SUBJECT: Forwards revised FSAR Section 14.2 Revs will be incorporated in next FSAR amend.

SUSQUEHANNA STEAM ELECTRIC STATION
FSAR SECTION 14.2
ER 100508 FILE 841-1
PLA-1962

In order to support obtaining an operating license for Susquehanna SES Unit 2, enclosed is a revised Section 14.2 of the Susquehanna SES FSAR. The revisions to this section are as follows:

FIGURE 14.2-1

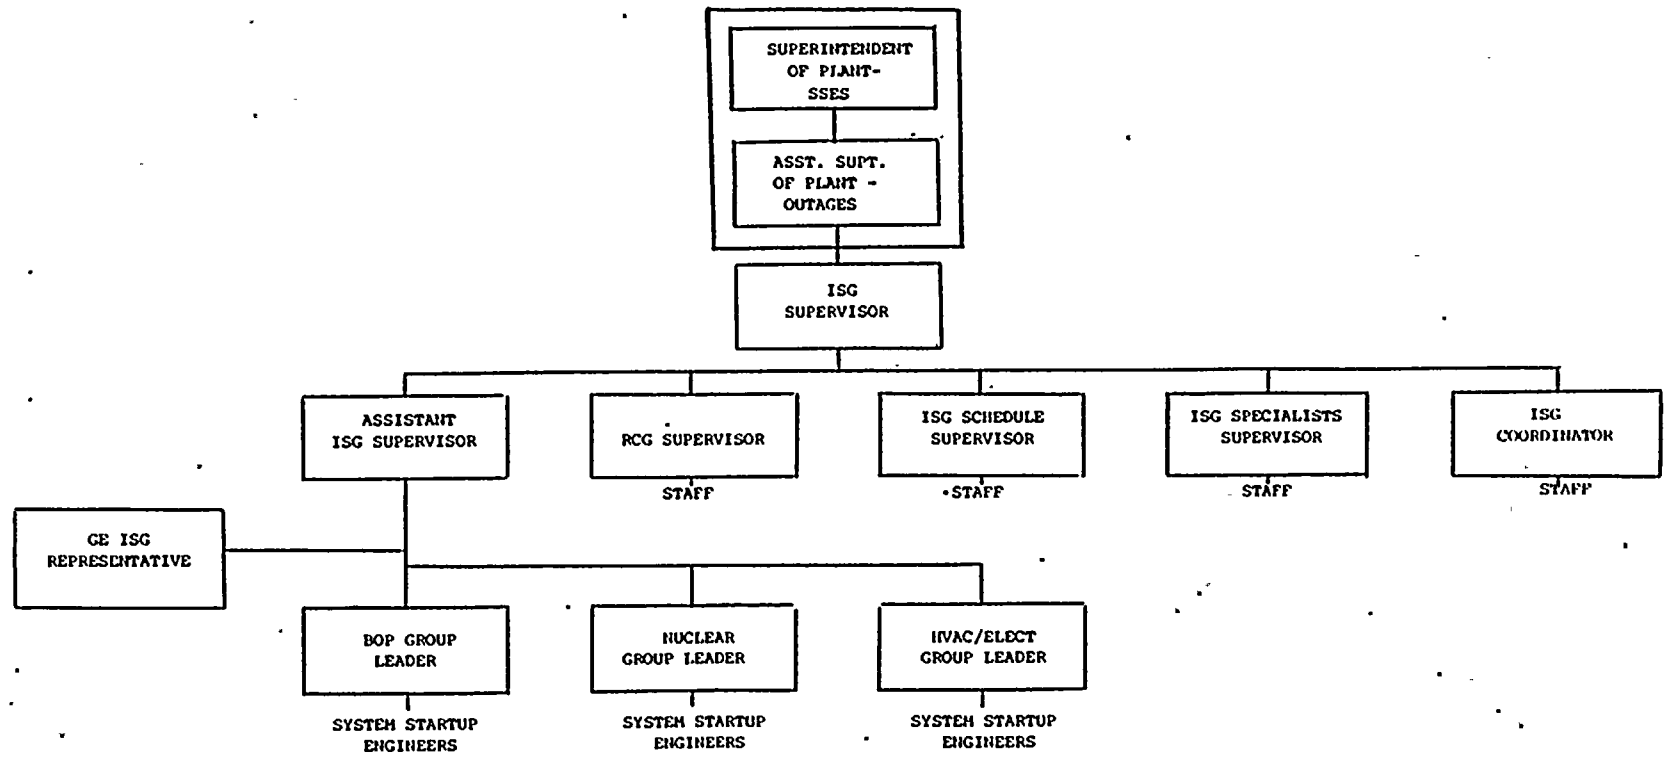
- 14.2.2.2.7 - This section was revised to indicate a title change for the Record Control Group Supervisor.
- 14.2.2.2.8 - This section was revised to indicate the responsibilities of GE during the Unit 2 test program.
- 14.2.12.1a and 14.2.12.4 - In P99.1 and P299.1, overspeed is only simulated on the main hoist. The anticollision system is tested during P299.1. During P299.1, only manual lowering is performed on the main hoist. Load sensing capability on the main hoist is not tested. The Unit 2 crane cannot be controlled by radio, therefore, it is not tested.
- 14.2.12.5 - The acceptance criteria for test A243.1 has been revised to delete the time requirement on the drawdown of the main condenser.
- Figure 14.2-1 - This figure has been revised to show the ISG organization for Unit 2.
